DEVELOPMENT DETERMINATION PANEL MEETING

WEDNESDAY 12 AUGUST 2020

ITEM 3.1	REV2020/0017 - 157 VICTOR ROAD, DEE WHY - REVIEW OF DETERMINATION OF APPLICATION DA2019/1179 ALTERATIONS AND ADDITIONS TO A DWELLING HOUSE
REPORTING MANAGER	Tony Collier
TRIM FILE REF	2020/449155
ATTACHMENTS	1 Assessment Report 2 Site Plan & Elevations 3 Clause 4.6

Application Number:	REV2020/0017
Responsible Officer:	Claire Ryan
Land to be developed (Address):	Lot A DP 378435, 157 Victor Road DEE WHY NSW 2099
Proposed Development:	Review of Determination of Application DA2019/1179 alterations and additions to a dwelling house
Zoning:	Warringah LEP2011 - Land zoned R2 Low Density Residential
Development Permissible:	Yes
Existing Use Rights:	No
Consent Authority:	Northern Beaches Council
Delegation Level:	DDP
Land and Environment Court Action:	No
Owner:	Philip Martin Spencer Sophie Justine Spencer
Applicant:	Philip Martin Spencer
Application Lodged:	12/05/2020
Integrated Development:	No
Designated Development:	No
State Reporting Category:	Refer to Development Application
Notified:	22/05/2020 to 05/06/2020
Advertised:	Not Advertised
Submissions Received:	3
Clause 4.6 Variation:	4.3 Height of buildings: 32.94

**CLAUSE 4.6 VARIATION – HEIGHT OF BUILDING
ALTERATIONS AND ADDITIONS TO EXISTING (INCOMPLETE) BUILDING
95 GURNEY CRESCENT SEAFORTH
UPDATED AUGUST 2020
Page 4**

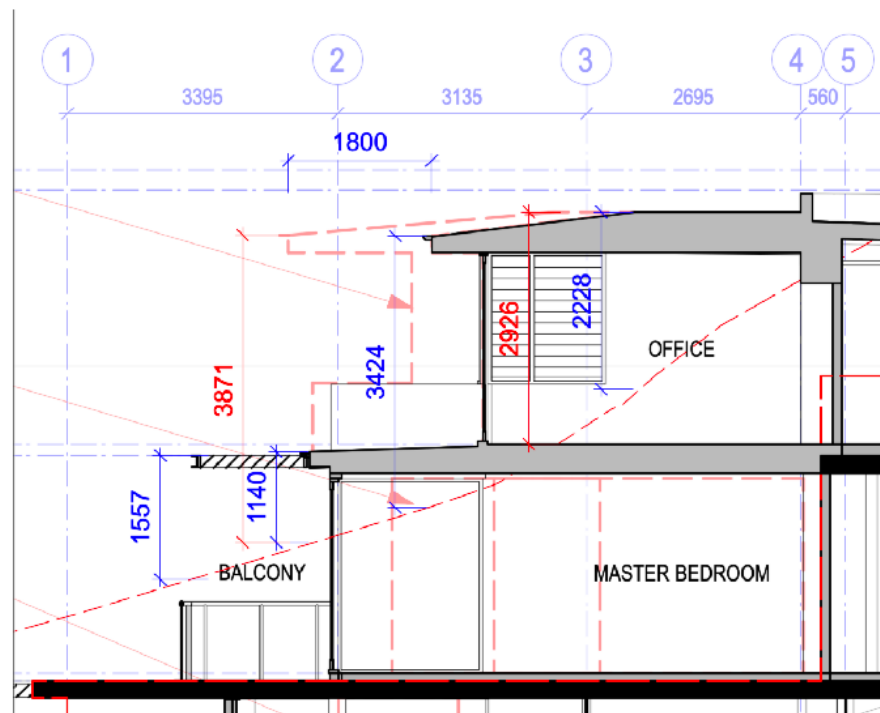
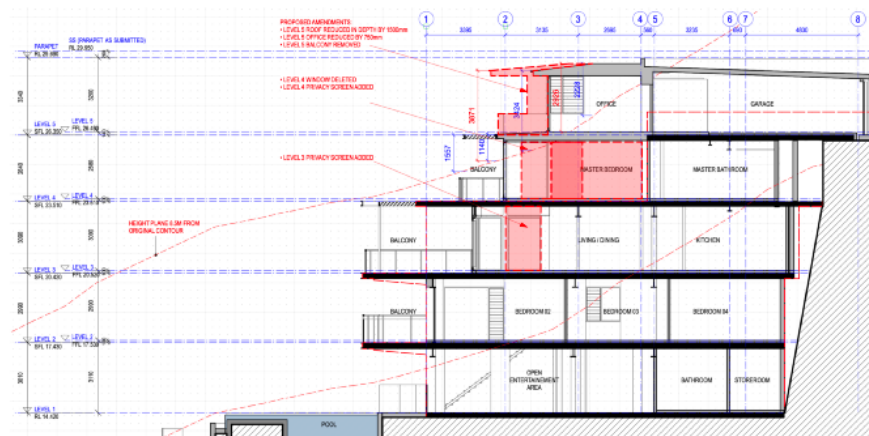
For the originally submitted design (show dashed red below), at the most extreme point, the highest point of building above the existing ground level would be 12.4m, which is 3.9m (3.87m) above the 8.5m height plane at that point. This can be seen in the attached diagram.

The amended design has reduced this level of non-compliance. Due to setting back the upper level, at the same point that the original non-compliance was 3.87m the noncompliance has been reduced to 1.14m. This was originally the gutter line to the Western eave of the office. This eave overhang was pushed back 1.8m. At this point now the gutter line is now 3.42m, a reduction of 447mm in height non-compliance.

At 3.42m added to the 8.5m height plane, that brings the overall height at the highest point to 11.92m. This can be calculated as a percentage as follows: $(11.92 - 8.5m) / 8.5m = 40\%$ variation.

Fig 2 – ENVELOPE COMPARISON

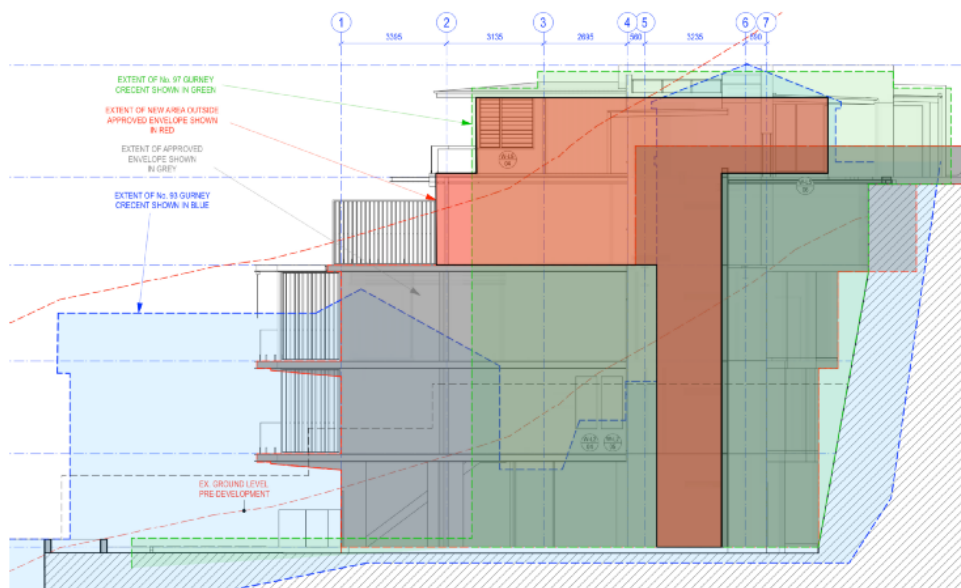
To further describe the difference between visible and invisible additional area, this can be seen in section – with an overlay of the neighbouring buildings as well so that it is possible to see where new area is matching existing (particularly No. 97)

The section diagram shows the new area in red and the existing approved envelope in grey. This sits against the neighbour at No.97 (in green) and the neighbour at No.93 (in blue).

Figure 1 - Eastern Elevation.

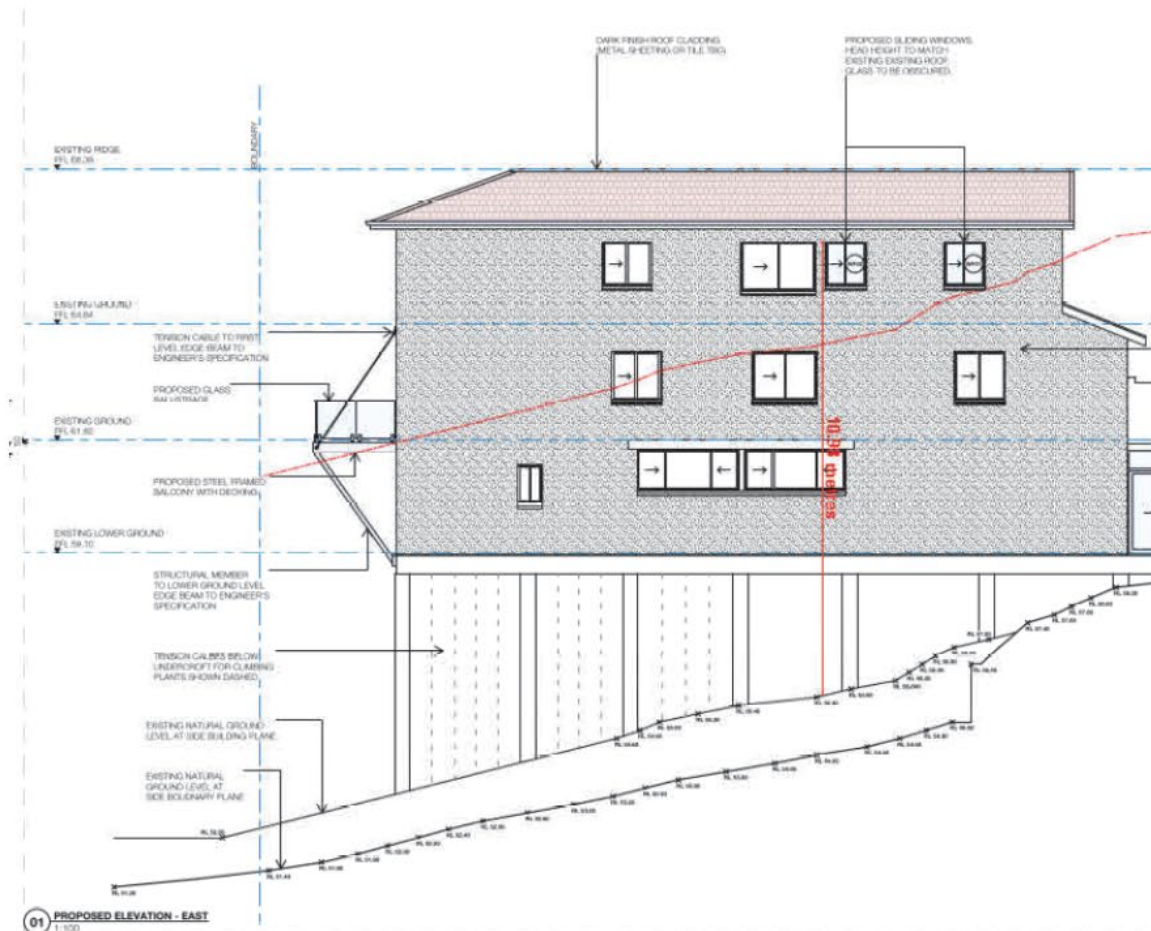
The area of non-compliance is limited to the top of the new window openings (10.98m), top of the new door openings (10.1m) and top of the new balconies balustrades (8.8m) associated with the alterations and additions. The figures below show the areas of non-compliant building:
